9.3 Process Auxiliaries

The information in this section of the reference ABWR DCD, including all subsections, tables, and figures, is incorporated by reference with the following departures and supplements.

STD DEP 9.3-1

Figure 9.3-12 Non-Radioactive Drainage System

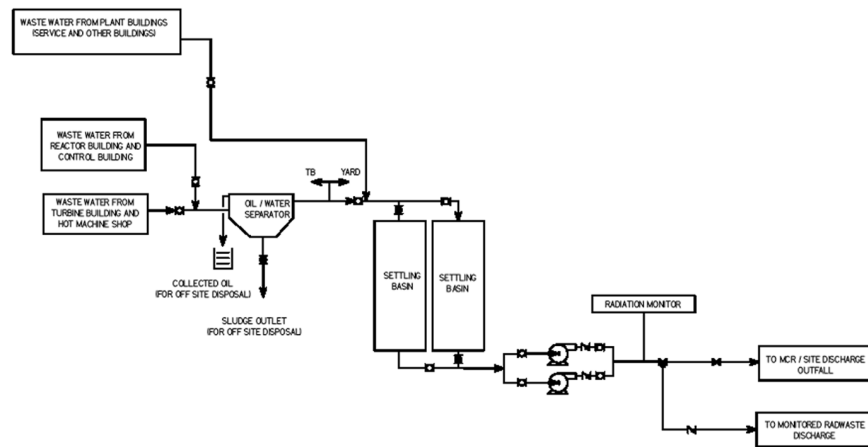
The design of the continuation of the non-radioactive drain system from the ABWR Standard Plant Buildings to the site discharge outfall is provided in Figure 9.3-12 and is discussed in this subsection.

The conceptual design information in this subsection of the reference ABWR DCD is replaced with the following site-specific supplement.

The non-radioactive drain system collects waste water from plant buildings (Reactor, Turbine, Control, Service, and other buildings). A system composed of collection piping, curbs, and pumps is provided. Non-radioactive waste water from the Turbine Building, Reactor Building, hot machine shop and the Control Building is routed to a dedicated oil/water separator where oil and settled solids are removed for off-site disposal. The non-oily, non-radioactive effluent is sent to dual settling basins. Non-radioactive waste water from the Service Building and other buildings is sent directly to the dual settling basins. Means are provided to perform any required tests or analyses required by the discharge permit. The non-radioactive liquid effluent is

discharged to the Main Cooling Reservoir through permitted outfall(s). If radioactivity levels exceed the limits for discharge, the flow from the non-radioactive drains has the capability to be diverted to the radioactive effluent portion of the radwaste system. Normally, if low levels of radioactivity are detected, it is quantified and discharged via the normal outfall. Higher levels of radioactivity may require a permitted "batch" discharge via the radwaste effluent radiation monitor. The non-radioactive drainage system is illustrated in Figure 9.3-12.
